AGENDA

**Extraordinary Council Meeting
20 September 2022**

Figure 1: Alternate Route.

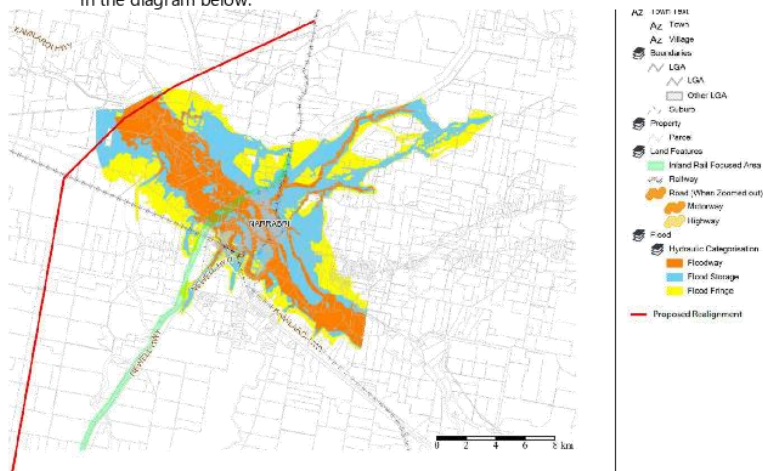
- a) The Flood Committee requests IR investigate the proposed alignment depicted in the diagram below:

Figure 2: Provisional 1% AEP Afflux of proposed N2N infrastructure.

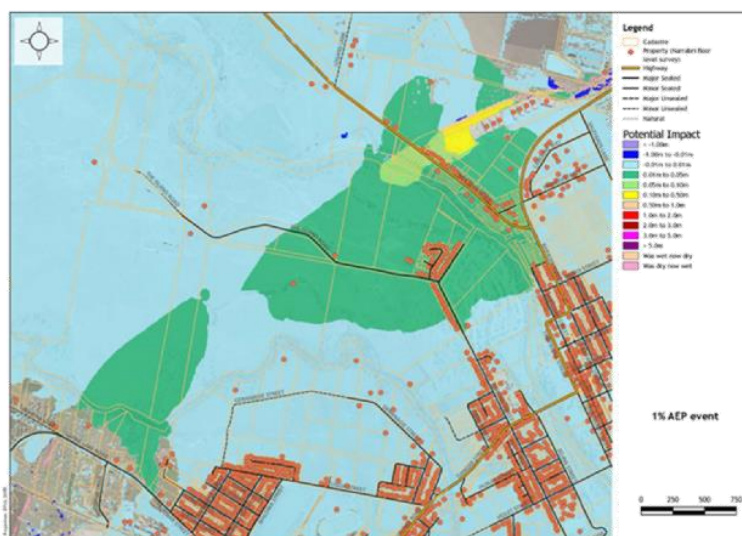
- developed their own. The Flood Committee questioned why IR's model did not include Mulgate Creek and local tributary flooding to which the Flood Committee still have to date not received an appropriate answer.
- d) A presentation was given by the IR N2N project team to the Flood Committee on 29 April 2020 outlining the status of the project and their flood investigations so far. The Flood Committee questioned the proposed location of the railway line immediately downstream of the township of Narrabri and highlighted the potential negative flood impacts on the town. Preliminary results showed a 1cm to 10cm increased afflux impact on Wee Waa Road and 1cm to 5cm impact for the Millicent Drive residential area for the 1% Annual Exceedance Probability (AEP) event as evidenced in the Figure below;

- e) IR have maintained that their target for all projects is to limit the afflux on existing buildings to 10mm (1cm). The results show some buildings having an afflux of between 1cm and 5cm.
